**Proposed Residential Development
at Lands at Capdoo & Abbeylands,
Clane, Co. Kildare**

ROAD SAFETY AUDIT STAGE 1 / 2

December 2020

2.1 Problem

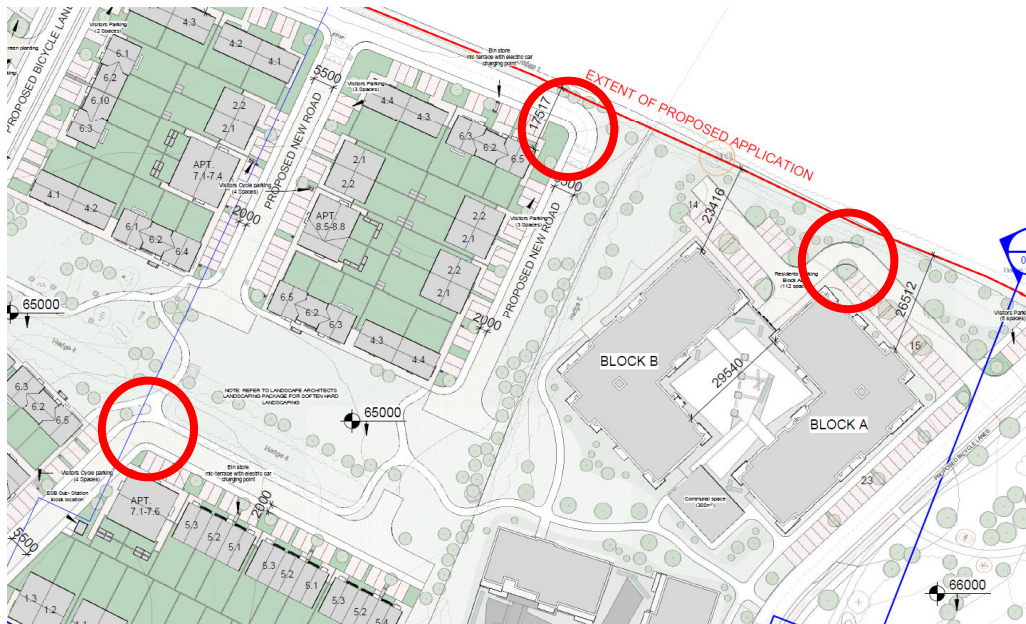
There are 2 no. locations where a raised ramp is provided adjacent to parking spaces. Drivers of vehicles may have difficulty in accessing these parking spaces which may contribute to a collision at these locations. In addition, it is unclear whether adequate inter-visibility is provided between drivers of vehicles approaching the pedestrian crossings and pedestrians stopped waiting to cross at the pedestrian crossings. Obstructions to visibility may include planting and parked vehicles adjacent to the pedestrian crossings.

Ensure the raised ramps do not interfere with drivers of vehicles accessing the parking spaces and ensure adequate inter-visibility is provided between drivers of vehicles approaching the pedestrian crossings and pedestrians stopped waiting to cross at the pedestrian crossings.

2.2 Problem

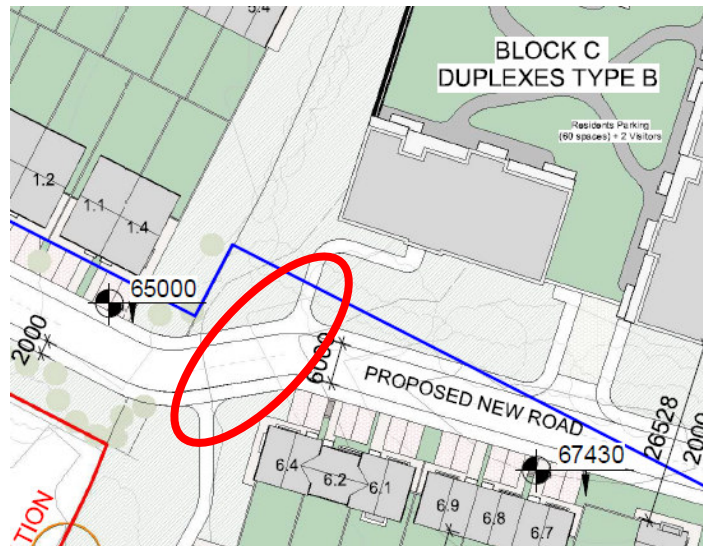
A Low radius bend is proposed at a number of locations within the proposed development. Two vehicles may have difficulty in passing one another at these location which may lead to a side swipe collision. Stopping sight distance at the bend may also be restricted by the proposed parking and boundary treatment on the inside of the bend.

Revise the layout at the bend to ensure that two vehicles can safely pass one another and that adequate stopping sight distance is provided.

2.3 Problem

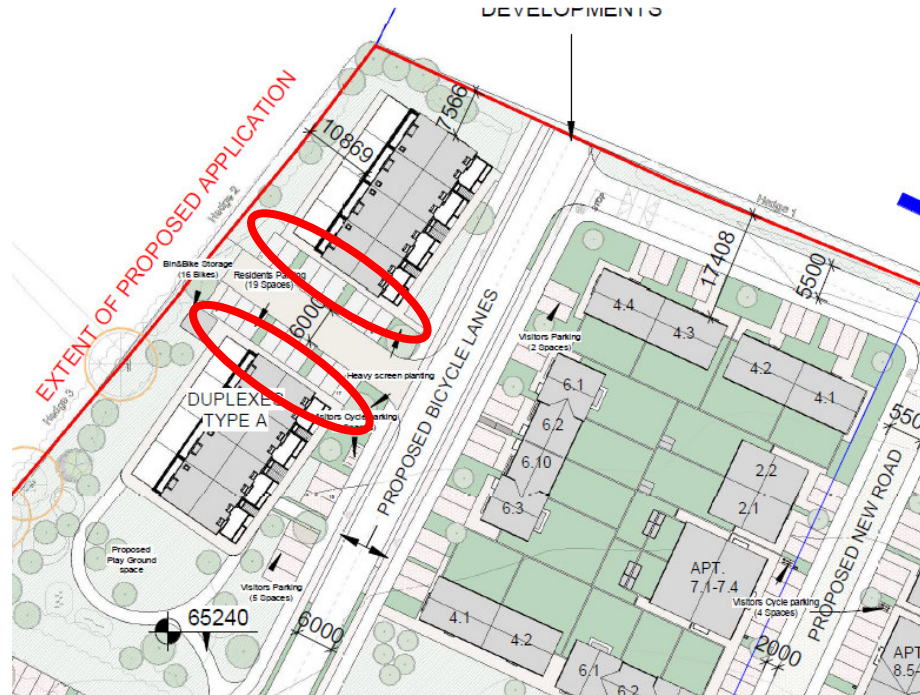
A pedestrian crossing is proposed adjacent to duplex dwellings at block C. However, the footpath on either side of the crossing do not align with one another which may lead to difficulties for visually impaired pedestrians crossing at this location

Revise the layout of the pedestrian crossing at this location to ensure that the correct alignment is provided.
